SUBJECT: SUSQUEHANNA STEAM ELECTRIC STATION, UNIT 2 (TAC NO. M97499)

AMENDMENT TO FACILITY OPERATING LICENSE

Amendment No. 139
License No. NPF-22

SAFETY EVALUATION BY THE OFFICE OF NUCLEAR REACTOR REGULATION

Figure 2.1.2-1
MCPR Safety Limit vs Core Flow

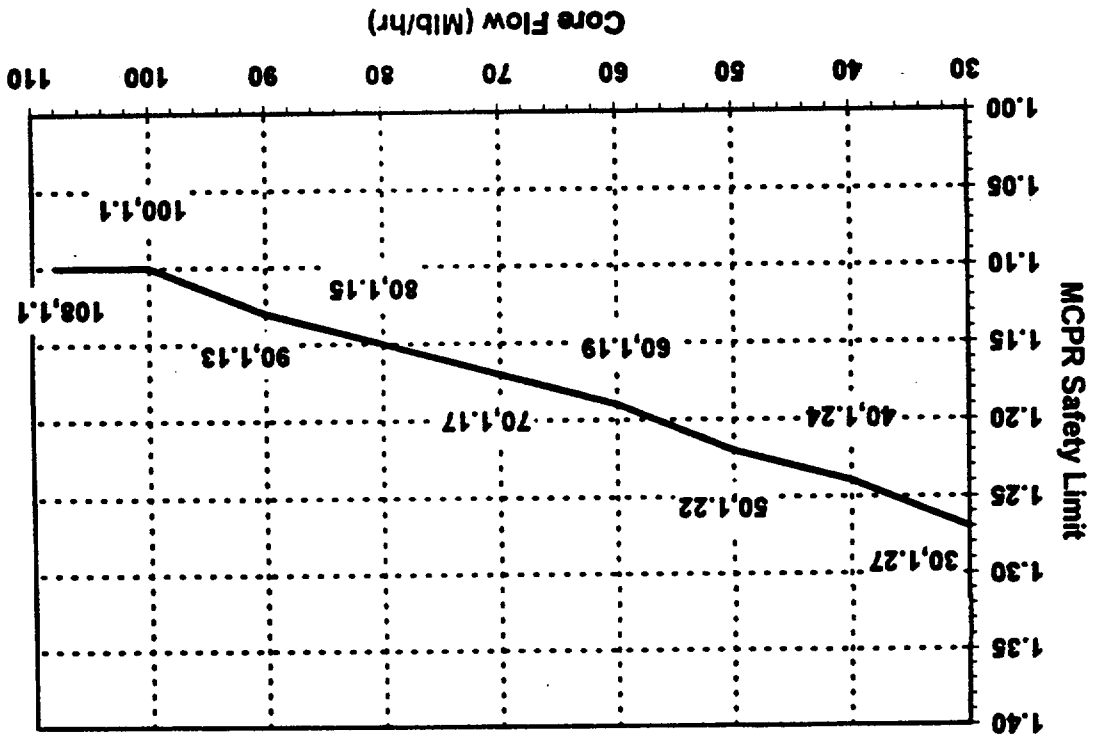
2.1.2 The MINIMUM CRITICAL POWER RATIO (MCPR) shall not be less than the value shown in Figure 2.1.2-1*# with the reactor vessel steam dome pressure greater than 785 psig and core flow greater than 10 million lbm/hr.

The safety limit MCPR in TS 2.1 and its associated Bases 2.0 is proposed to change from 1.08 to the value shown in Figure 2.1.2-1 (≥ 1.11 depending on the core flow) for operation with two recirculation loops with the reactor vessel steam dome pressure greater than 785 psig and core flow greater than 10 million lbm/hr., and from 1.09 to the value shown in Figure 3.4.1.1.2-1 (≥ 1.22) for single loop operation (SLO) based on the cycle-specific analysis of a modified ANFB core flow dependent SLMCPR performed by SPC for S2C9 mixed core of ATRIUM-10/SPC 9x9-2 fuel (Reference 8).

The staff in conjunction with our consultant at BNL has reviewed the proposed TS and its associated Bases changes and has found them acceptable since they are based on the analyses performed using S2C9 cycle-specific inputs and approved methodologies in Reference 3. The details of our evaluation are provided in the attachment to this safety evaluation.

Figure 3.4.1.1.2-1
MCPR Safety Limit vs Core Flow
Single Loop Operation

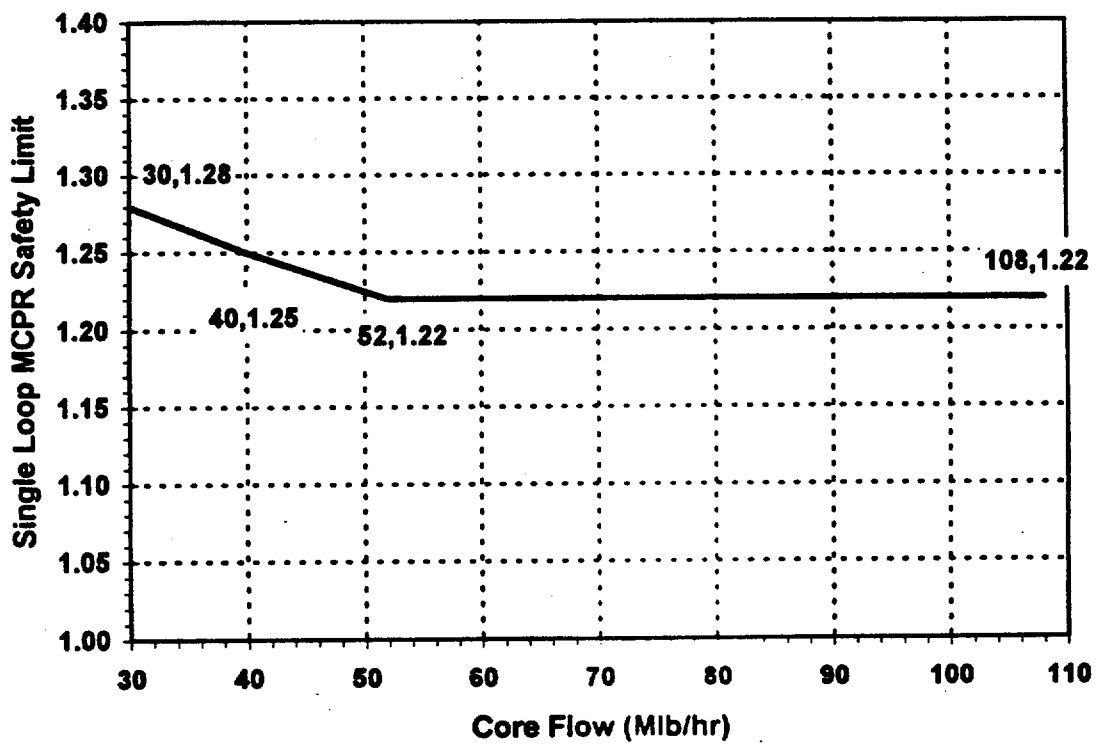
1. Specification 2.1.2: the MCPR Safety Limit shall be increased to the value shown in Figure 3.4.1.1.2-1⁺⁺.
2. Table 2.2.1-1: the APRM Flow-Biased Scram Trip Setpoints shall be as follows:
